August 10, 2001

Quad Cities Nuclear Power Station, Units 1 and 2  
Facility Operating License Nos. DPR-29 and DPR-30  
NRC Docket Nos. 50-254 and 50-265

**Subject:** Response to Request for Additional Information Concerning Risk Informed Inservice Inspection Program Alternative to the ASME Boiler and Pressure Vessel Code Section XI Requirements for Class 1 and 2 Piping Welds

**Response to Request for Additional Information,  
Risk Informed Inservice Inspection Program Alternative to the  
American Society of Mechanical Engineers, Boiler and Pressure Vessel Code, Section XI,  
Requirements for Class 1 and 2 Piping Welds**

**Figure RAI 9-A Comparison of Inspection Effectiveness Factors for EPRI RI-ISI Exams at QC Units 1 and 2**

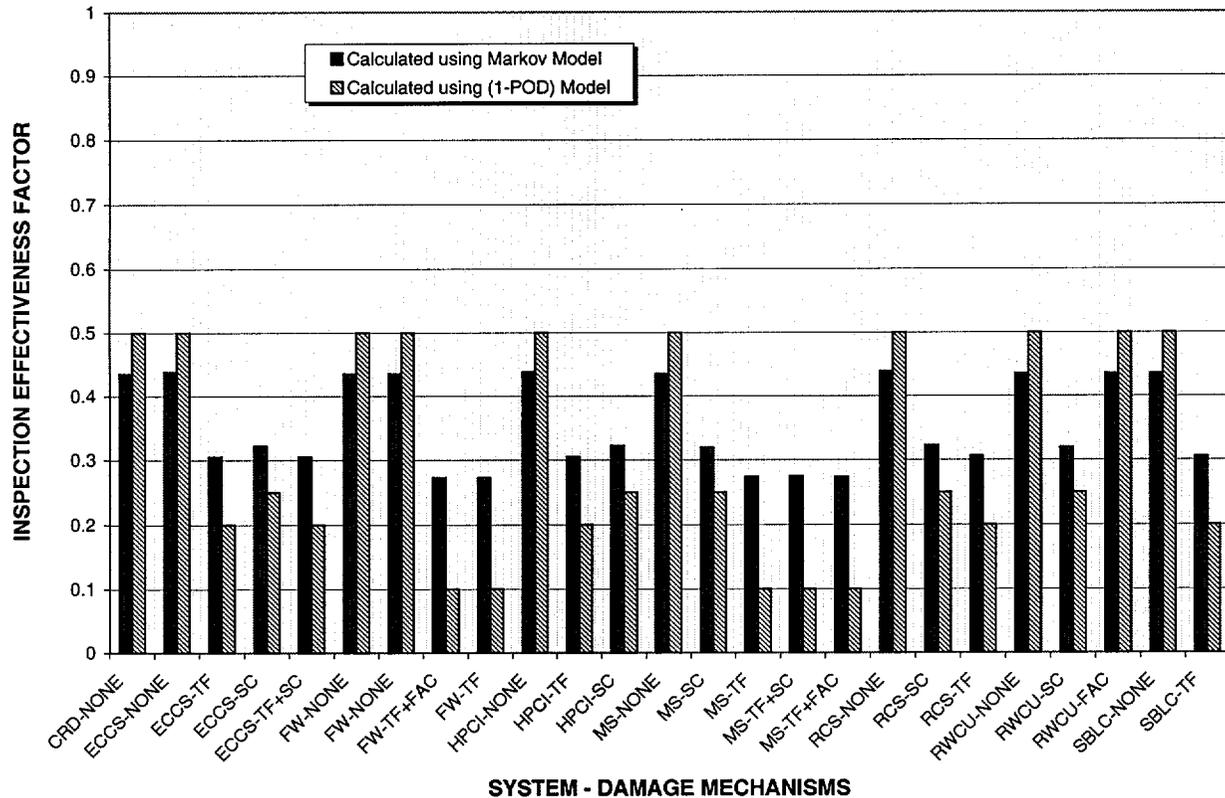
It is our understanding that you are calculating an inspection effectiveness factor (IEF) for use in equation 3-9 of EPRI TR-112657. Please provide a table identifying the probability of detection, the time to detect a leak, and the resulting IEF for all the IEFs used in the submittal.

A tabulation of all the unique inspection effectiveness factors for all pipe segments evaluated within the scope of the RI-ISI evaluation for QC Units 1 and 2 is presented in Table RAI 9-A. For comparison purposes, the corresponding POD values that were used were presented along with their complements that provide the alternative method of computing the inspection effectiveness factor. A plot that compares the two approaches to computing the inspection effectiveness factors is provided in Figure RAI 9-A for the RI-ISI exams.

As seen in these exhibits, there is fairly good agreement between these alternative approaches to estimating the inspection effectiveness factors. When the POD values are around 0.50, the Markov model predicts a somewhat higher level of inspection effectiveness, as reflected in somewhat lower inspection effectiveness factors. For higher POD values, the Markov model predicts a somewhat lower level of inspection effectiveness, as reflected in somewhat higher inspection effectiveness factors. Details documenting the inputs to computing these factors are discussed in response to question 8 above.
